CRUISER  
AIRCRAFT

No.: SB-SC-102

# SERVICE BULLETIN

| <b>SUBJECT:</b>           | Accomplishment of ROTAX Bulletin SB-912-078UL / SB-912-078. Exchange of propeller shaft on ROTAX Engine Type 912S and 912ULS   |

Fig. 2: Propeller shaft

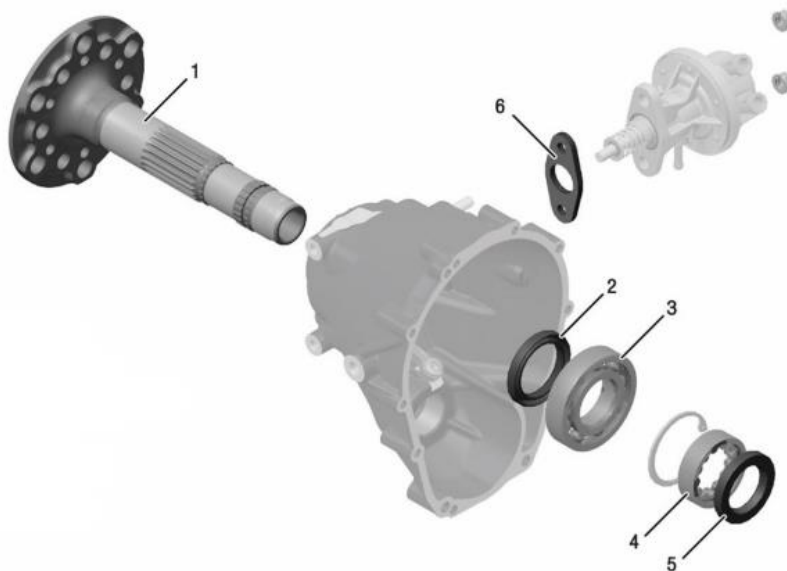
- 1) Check the criteria given on page 1, if the aircraft engine is affected by this SB.
- 2) Check the engine logbook and maintenance documentation, if this SB has already been accomplished.
- 3) Move the aircraft to a place suitable to perform the work.
- 4) Following instructions in the current Maintenance Manual Heavy (MMH) and Maintenance Manual Line (MML), perform the following tasks:
  - Remove gearbox assy. from the engine.
  - Disassemble gearbox and press out affected propeller shaft.
  - Reassemble the gearbox using a new propeller shaft, oil seal and ball bearing.
  - Remove crankcase side propeller shaft roller bearing and oil seal and replace with new.
  - Attach gearbox assy. to crankcase.
  - In the case of an engine installed in an aircraft, perform an engine test run.

| PART No. | QUANTITY | DESCRIPTION           | APPLICATION            |
|----------|----------|-----------------------|------------------------|
| 937047   | 1        | Propeller shaft       | Version 2              |
| 832587   | 1        | Ball bearing 35-72-17 | Gearbox side           |
| 950470   | 1        | Oil seal 40x55x7      | Gearbox side           |
| 232246   | 1        | Roller bearing        | Crankcase side         |
| 950200   | 1        | Oil seal 30x52x7      | Crankcase side         |
| 950228   | 1        | Isolating flange      | Fuel pump (912 Series) |
